Office Action Summary	Application No. 10/500,583	Applicant(s) WEBJORN, JAN	
	Examiner NAHID AMIRI	Art Unit 3679

DETAILED ACTION

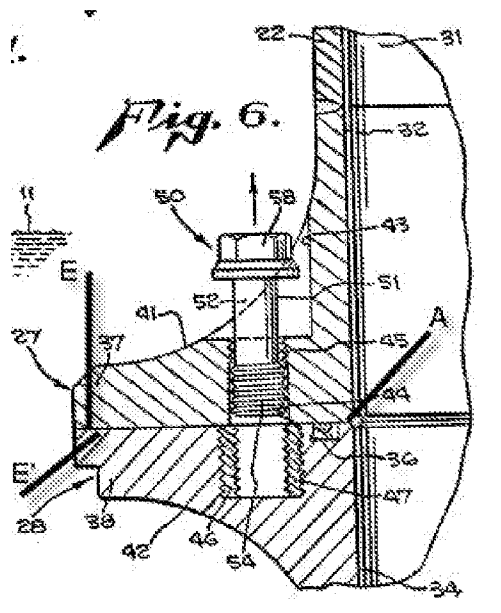
Claim 1 is rejected under 35 U.S.C. 102(b) as being anticipated by US Patent No. 4,183,562 Watkins et al.

With respect to claim 1, it should be noted that the claim drawn only to one flanged member. Accordingly, as claimed, Watkins et al. disclose a flanged member (Fig. 6) configured to be included as a first flanged member (37) in a flanged joint in a pressure equipment device, the flanged joint comprising the first flanged member (27) and a corresponding second flanged member (38) with a second flanged end having a second end surface (E', please see Examiner's markup), said first flanged member (37) comprising a first flanged end with a first end surface (E, please see Examiner's markup) which capable of corresponding to the second end surface (E') of the second flanged end of the second flanged member (38), an entirety of the first load transferring surface positioned and configured to face the second end surface (E'); at least a portion of the first load transferring surface in an unstressed condition being concave (constituted by a curved portion of an innermost portion of the first flange 37) in radial direction, such that the at least the portion of the first load transferring surface is curved and defined by a concave curve function, the first end surface (E) comprising a first load transferring surface through which forces are transferred when assembled together with the corresponding second flanged

member; in a radial direction; wherein load transferring surface has an outermost abutment point (A) in a cross section of the first flanged member (37), the outermost abutment point (A) configured to abut against the second end surface of the second flanged member (38) when assembled together with said corresponding second flange member (38), the outermost (A) abutment point being the abutment point situated farthest in the radial direction from the central axis of the first flanged member (37), said load transferring surface has an innermost abutment point in a cross section of the first flanged member, the innermost abutment point configured to abut against the second end surface of the second flanged member when assembled together with said corresponding second flange member, the innermost abutment point being the abutment point situated nearest in the radial direction from the central axis of the first flanged member (37); and a boring (44) passing through the first end surface (E) at a radial distance from a central axis of the first flanged member (37) greater than the radial distance from the central axis of the first flanged member (37) to the innermost abutment point, and less than the radial distance from the central axis of the first flanged member to the outermost abutment point.

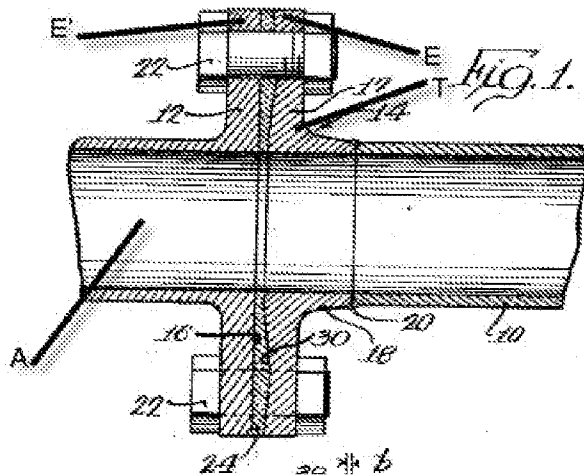
Claims 1, 2, 5-8 , 10, 14, 15, 17, and 18 are rejected under 35 U.S.C. 103(a) as being unpatentable over US Patent No. 2,940,779 Buono.

With respect to claims 1 and 2, it should be noted that the claim drawn only to one flanged member. Accordingly, as claimed, Buono discloses a flanged member (Fig. 1) configured to be included as a first flanged member (14) in a flanged joint in a pressure equipment device, the flanged joint comprising the first flanged member (14) and a corresponding second flanged member (12) with a second flanged end having a second end surface (E, please see below Examiner's markup), said first flanged member (14) comprising a first flanged end with a first end surface (E, please see below Examiner's markup) which capable of corresponding to the second end surface of the second flanged end of the second flanged member (12), the first end surface (E) comprising a first load transferring surface through which forces are transferred when assembled together with the corresponding second flanged member; in a radial direction; wherein load transferring surface has an outermost abutment point in a cross section of the first flanged member (14), the outermost abutment point configured to abut against the second end surface of the second flanged member (14) via the gasket (16) when assembled

together with said corresponding second flange member (14), an entirety of the first load transferring surface positioned and configured to face the second end surface (E'); the outermost abutment point being the abutment point situated farthest in the radial direction from the central axis of the first flanged member, said load transferring surface has an innermost abutment point in a cross section of the first flanged member (14), the innermost abutment point configured to abut against the second end surface (E') of the second flanged member (12) when assembled together with said corresponding second flange member (12), the innermost abutment point being the abutment point situated nearest in the radial direction from the central axis of the first flanged member (14); and a boring passing through the first end surface (E) at a radial distance from a central axis of the first flanged member (14) greater than the radial distance from the central axis of the first flanged member (14) to the innermost abutment point, and less than the radial distance from the central axis of the first flanged member (14) to the outermost abutment point.

Buono fails to disclose that at least a portion of the first load transferring surface in an unstressed condition being concave such that the concave of the first end surface is curved; and wherein the first load transferring surface is concave over the entire extension thereof in the radial direction.

It would have been obvious to one of ordinary skill in the art at the time of invention was made to form the concave of the first end surface as a curve instead of forming it from multi-straight lines, since there is no known criticality associated with the concave being curved and it is well-established that changes in shape are obvious expedients. The change in shape of the concave produces no new and unexpected results.

With respect to claim 10, Buono discloses (Fig. 1) that at least a part of a transition area (T) (see attachment), between the surface of the flange directed away from the end surface (30) and a part of the first flanged member that is substantially parallel to a longitudinal axis of the member, is shaped as a substantially elliptical area.
